P 515050-B

SEWAGE DISPOSAL SYSTEM
HOWARD COUNTY HEALTH DEPARTMENT
BUREAU OF ENVIRONMENTAL HEALTH
410-313-2640

UBDIVISION Peacefields @ Cattail Creek LOT NUMBER 2 ADDRESS 15524 Cattail Oaks

CLARK • FINEFROCK & SACKETT, INC. ENGINEERS • PLANNERS • SURVEYORS 7135 MINSTREL WAY • COLUMBIA, MD 21045 • (410) 381-7500 BALT. • (301) 621-8100 WASH.	
		DESIGNED DRAWN CHECKED DATE	LOCATION DRAWING 15524 CATTAIL OAKS LOT 2 PEACEFIELDS AT CATTAIL CREEK LOTS 1 THRU 15 AND PRESERVATION PARCELS 'A' THRU 'C' ZONED: RR-DEO (A RESUBDIVISION OF LOTS 1 AND 2, "PEACEFIELDS - LOTS 1 AND 2", PLAT No. 11105) FOURTH ELECTION DISTRICT HOWARD COUNTY, MARYLAND

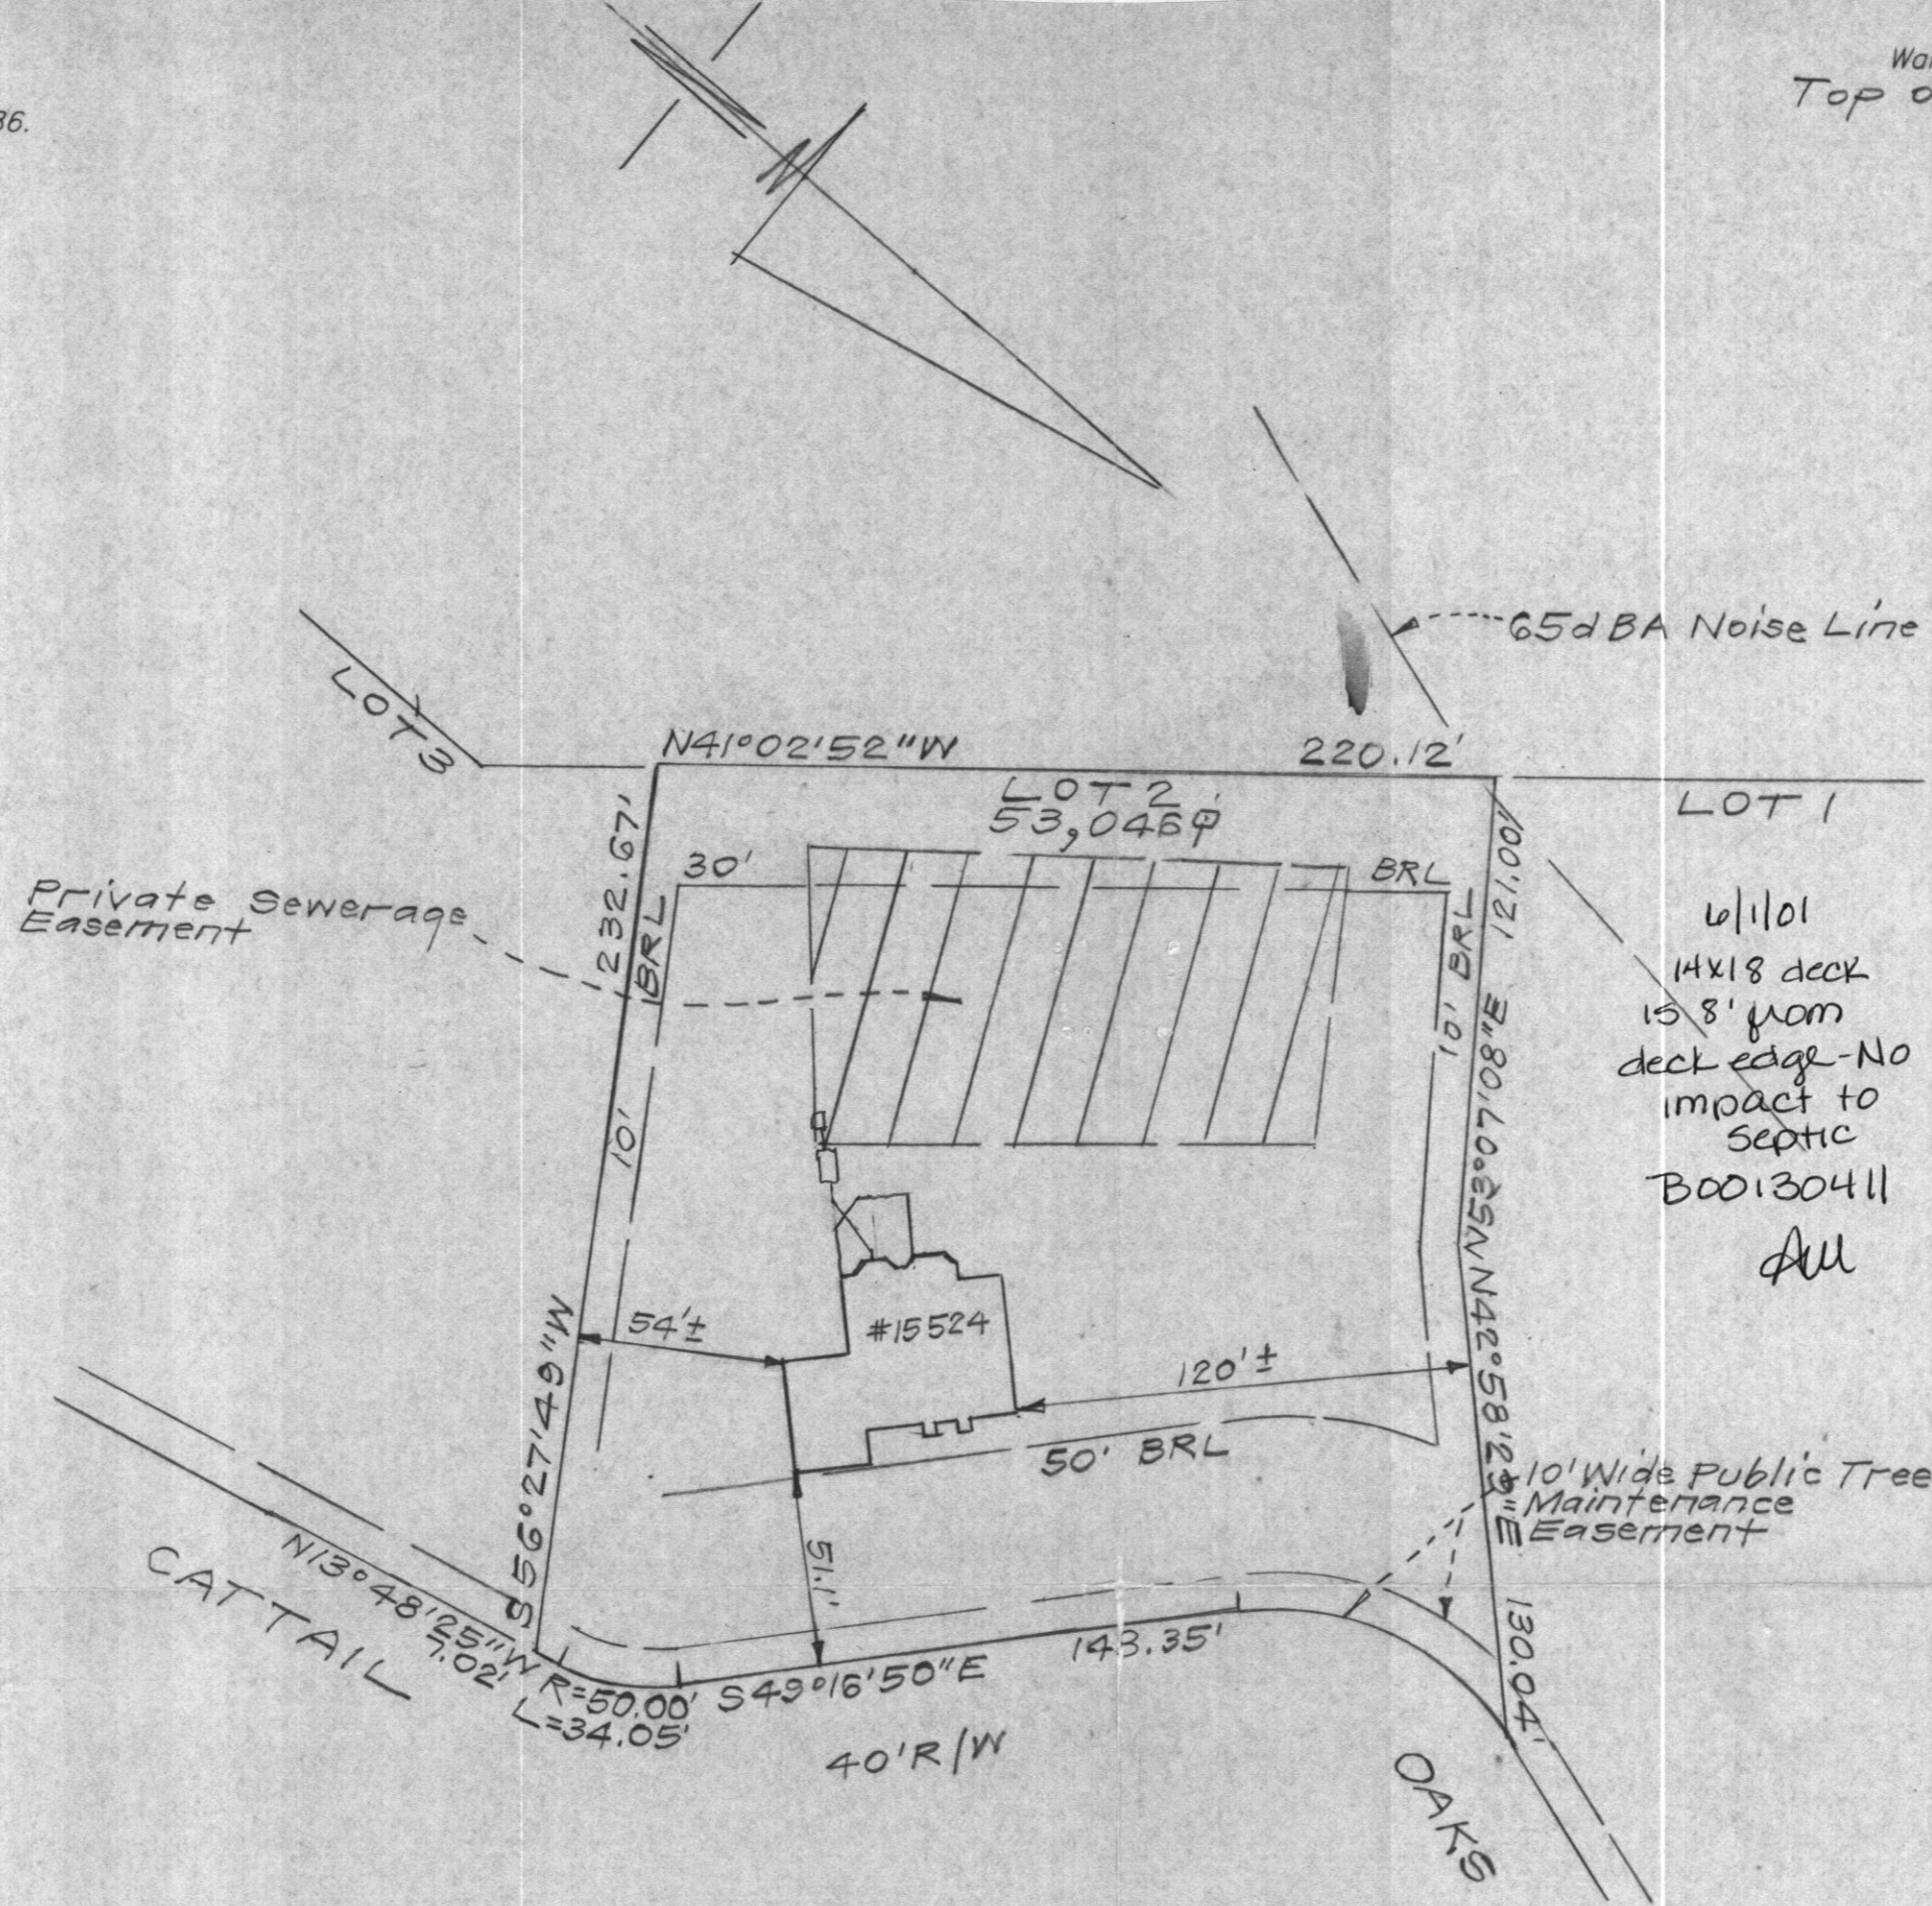
WELL LINE SHOULD BE SLEEVED IF IT RUNS UNDER THE DRIVEWAY

KEEP TANK OUTSIDE OF 100' RADIUS FOR WELL

PRE-CONSTRUCTION INSPECTION: 4/27/01 To install system similar to BP plan (BB)

INSPECTION COMMENTS: 4/27/01 Tank set, House connection made. (BB)

4/30/01 System satisfactory. O.K. to cover everything. (BB)

4/17/01 -
Wall Check
different from
approved BP Plan
but no impact
to well or septic
OK SRM
